то:	CHAIR AND MEMBERS – BUILT AND NATURAL ENVIROMENT COMMITTEE MEETING
FROM:	D. N. STANLAKE DIRECTOR OF DEVELOPMENT PLANNING
SUBJECT:	APPLICATION BY: SCHLEGEL ENTERPRISES INC. 1390 HIGHBURY AVENUE NORTH PUBLIC SITE PLAN MEETING OCTOBER 31, 2011 AT 4:45 PM

That on the recommendation of the Director of Development Planning, the following actions be taken with respect to the site plan approval application of Schlegel Enterprises Inc for a 128 unit Long Term Care facility at 1390 Highbury Avenue North:

The purpose of this application is to obtain site plan approval for a new 128 unit Long Term Care facility located at 1390 Highbury Avenue North. The application for site plan approval has been made to ensure the development takes a form compatible with adjacent land uses.

Site Plan

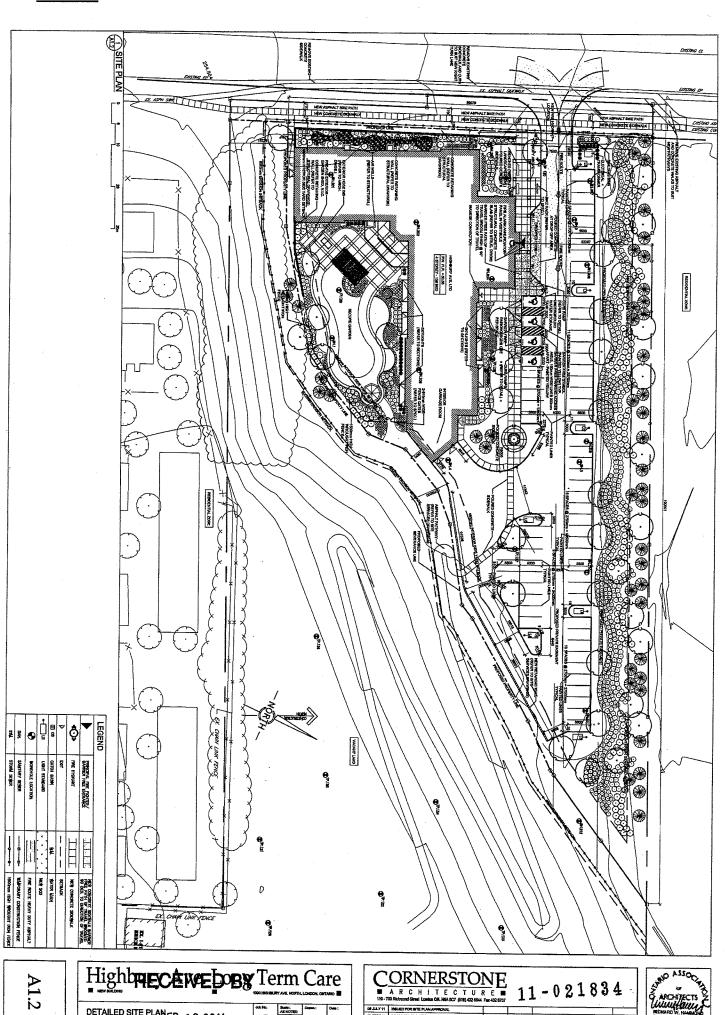
- The location of the building as proposed, complies with the intent of the Holding Residential R7 Special Provision approved by Municipal Council on 23 February 2009;

- 5. Confirm that the pedestrian walkway connecting the proposed project to the adjacent properties to the east, as required by the Holding Residential R7 Special Provision approved by Municipal Council on 23 February 2009, has been provided across the lower and upper slopes, and has been or will be paved as part of this project;

- Introduce a rolled curb to the patient drop-off area to mitigate the risk that pedestrians will trip over the curb given the narrowness of the sidewalk north of the proposed main entrance;

- 7. Reinforce the hard surfacing layout north of the main building entrance by substituting concrete for the asphalt proposed within the patient drop-off area;

- 8. Detail the proposed cast-in-place concrete retaining wall complete with ornamental railing, west of the building along the westerly property line;

- 11. Use pervious pavement in select areas of parking lots; and
- 12. Collect rain water in an underground cistern for use watering plants and shrubs within the secure garden.

Landscape Plan

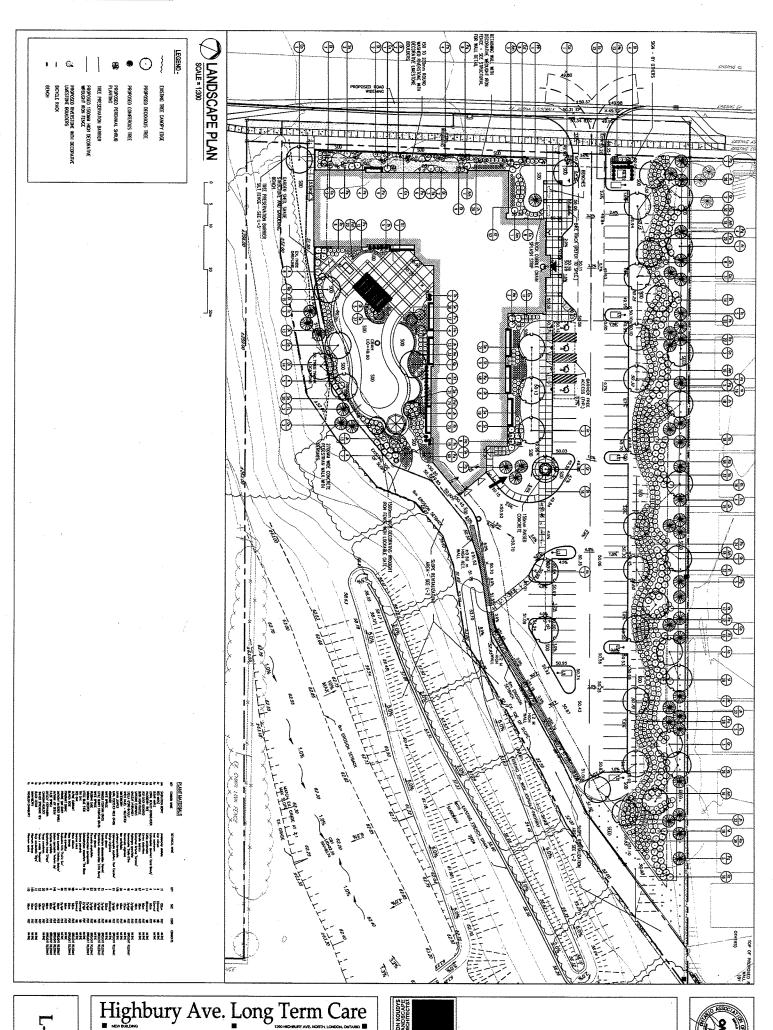
- 2. Extend/continue the width of the sidewalk under the pergola west to meet the municipal sidewalk on the east side of Highbury Avenue;
- 3. Provide a landscape plan documenting the intensive tree planting scheduled to be installed north of the parking lot parallel to the northerly property line; *NOTE: provided post meeting.*

- Provide a landscape plan documenting rehabilitation of the lower and upper slopes to the south of the proposed project as required by the Holding Residential R7 Special Provision approved by Municipal Council on 23 February 2009; NOTE: provided post meeting.

The landscape plan provides extensive landscaping along the Highbury Avenue North frontage such that an urban character will be created.

Elevations

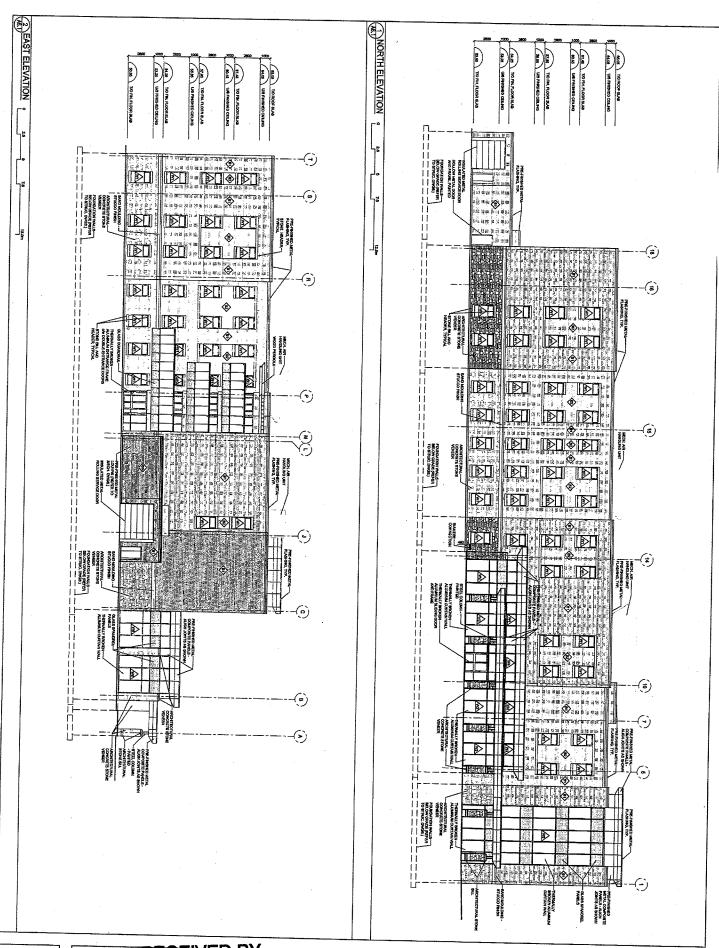
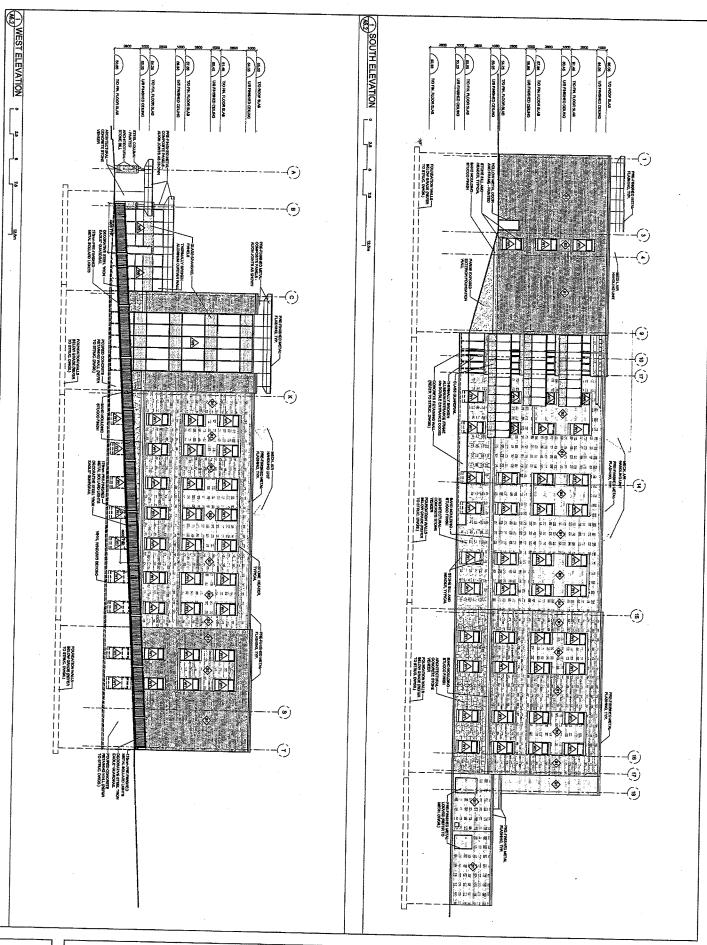
- 9. Additional delineation of the elevations particularly the west and north elevations is required to reduce the monolithic brick panels;
- 10. Improve the quality of the patient rooms that face north and look over the entrance and amenity area roofs by introducing green roofs;

The proposal was presented to the Urban Design Peer Review Panel and they did not express any concerns with the building architecture. The City's Urban Design Section has accepted the proposed elevations.
